The U.S. Environmental Protection Agency (EPA) has reviewed the draft Environmental Impact Statement (EIS) for the **Klamath Hydroelectric Project** (CEQ No. 20060395) (Project) located principally on the Klamath River in Klamath County, Oregon and Siskiyou County, California, between Klamath Falls, Oregon and Yreka, California. Our review has been conducted in accordance with our responsibilities under the National Environmental Policy Act (NEPA) and Section 309 of the Clean Air Act.

**Klamath Hydroelectric Project
Draft Environmental Impact Statement
EPA Detailed Comments**

Figure 1 : Plot of Temperature Shift below Iron Gate Dam based on Pacificorp Model (draft EIS, Figure 3-37)

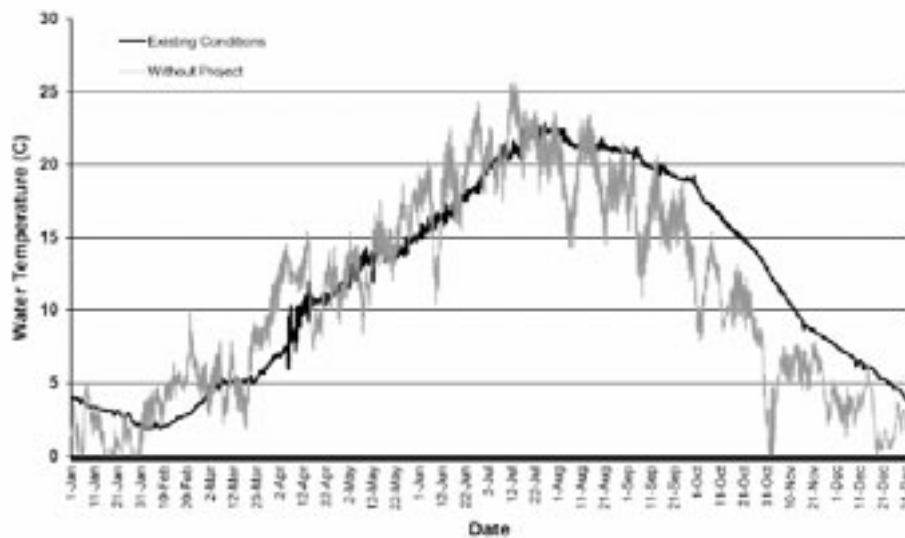
The draft EIS indicates that, by causing a shift in the seasonal thermal regime, Copco No.1 and Iron Gate Dams directly impact the temperatures of the downstream Klamath River (see Figure 1 below). Temperature increases in the Fall are of particular concern because they would exceed the 2.8° C (5° F) allowable increase in California water quality criteria (Table 3-24). The draft EIS does not clearly explain how these increases are consistent with the California narrative criteria that state “At no time shall temperature be increased by more than 5° F above natural receiving water temperature.” While the full impact of the dams on the applicable California water quality standards has not yet been fully analyzed in a TMDL, information presented by Bartholow, et al, 2003 (see Figures 2, 3, 4 and 5 below) indicates that significant reductions in Fall outflow temperatures would be needed to achieve California’s applicable water quality criteria for temperature (no greater than 2.8° C increase).

Figure 6: Plots from Tetra Tech Draft Modeling Report (unpublished) showing calibration runs for various water quality parameters compared to their current conditions monitoring results.

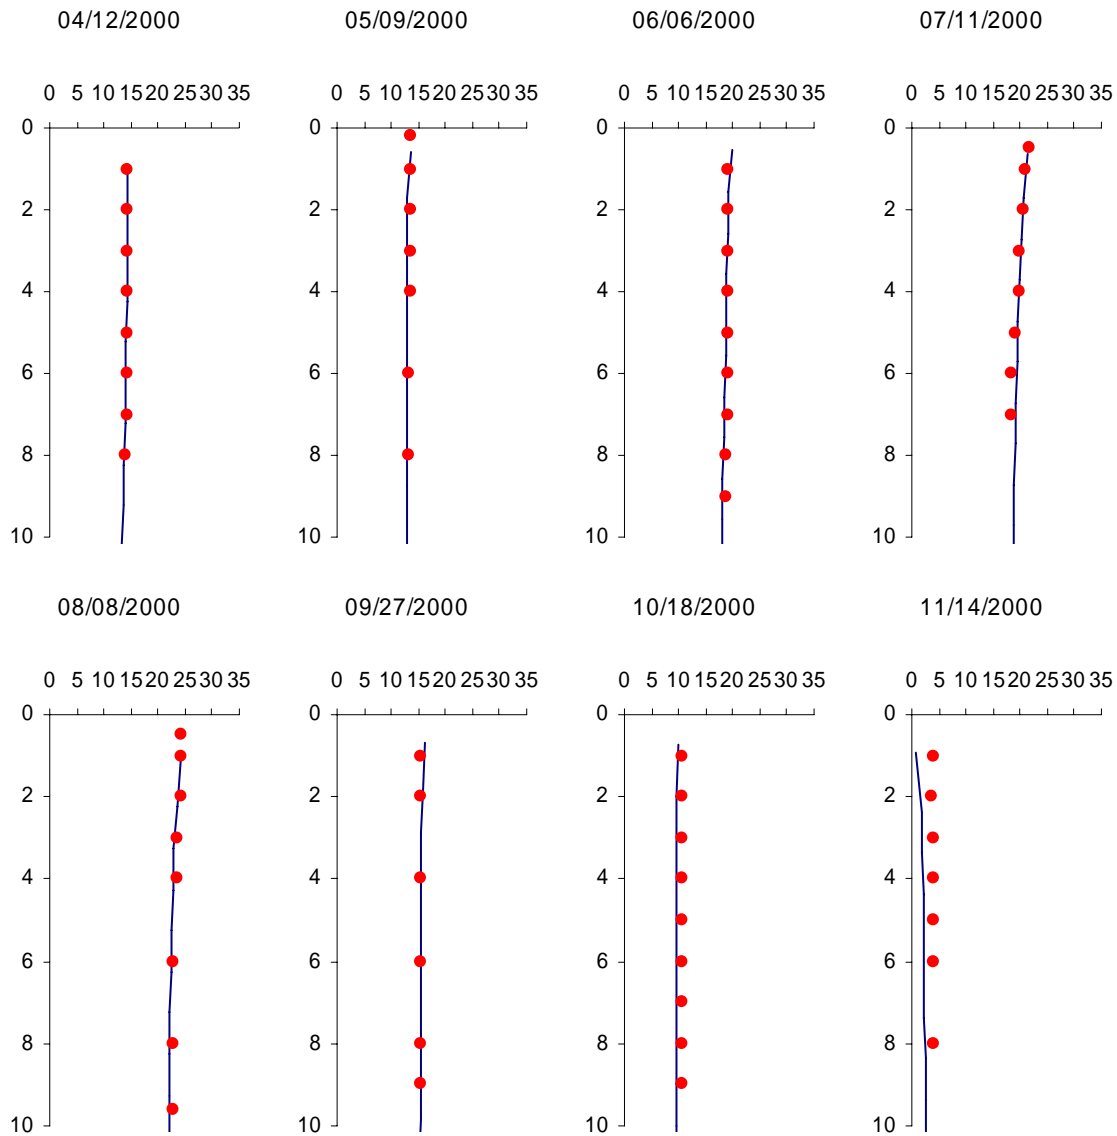
The draft EIS presents an analysis of temperature and dissolved oxygen criteria exceedences below Iron Gate Dam; temperature above and below J.C. Boyle; and, temperature within Copco No.1 and Iron Gate reservoirs, but similar analyses are not presented for all Project structures or for waters between the structures. Similarly, the draft EIS does not include a complete analysis of the Project’s compliance with pH and ammonia water quality criteria. Data developed by Oregon and California in the course of their TMDL analysis indicates that there would be exceedences of temperature, dissolved oxygen, pH, and ammonia water quality criteria

throughout the Project area at various times of the year (see attached model calibration results prepared by Tetra Tech (Figures 6, 7 and 8 below)).

We recommend that the final EIS include a more thorough analysis of all relevant water quality parameters for each Project structure and the waters between the structures and discuss the impacts the Project has on applicable state and tribal water quality standards. Such an evaluation would provide important information regarding whether a proposed alternative is consistent with all applicable state and tribal water quality standards.

Figure 9: Estimated Effects of Flow Fluctuation on Temperature Below J.C. Boyle Powerhouse Discharge.

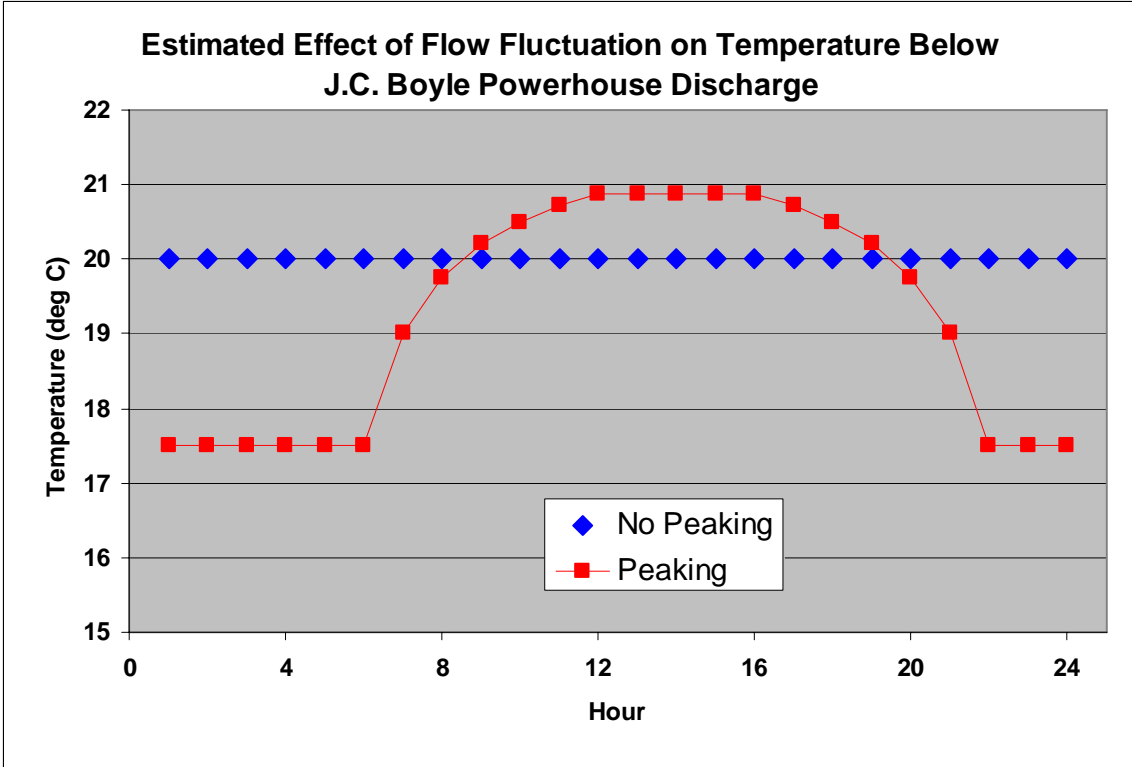
The draft EIS does not include an analysis of the impacts of peaking operations at the J.C. Boyle powerhouse on exceedences of the Oregon water quality temperature standard downstream from the dam. While the document discusses how the powerhouse increases the diel range of temperatures observed in the bypass reach, Oregon water quality standards include requirements to restrict human-caused increases to maximum temperatures. EPA performed a screening calculation on information in the draft EIS based on river flows and temperatures. Our calculation indicates that peaking may increase the maximum daily temperature downstream of the powerhouse compared to temperatures under steady powerhouse flows (see Figure 9 below).

EPA recommends that the final EIS include a more thorough evaluation of the effects of peaking at the J.C. Boyle Dam on temperature and the implications for achieving Oregon water quality standards.
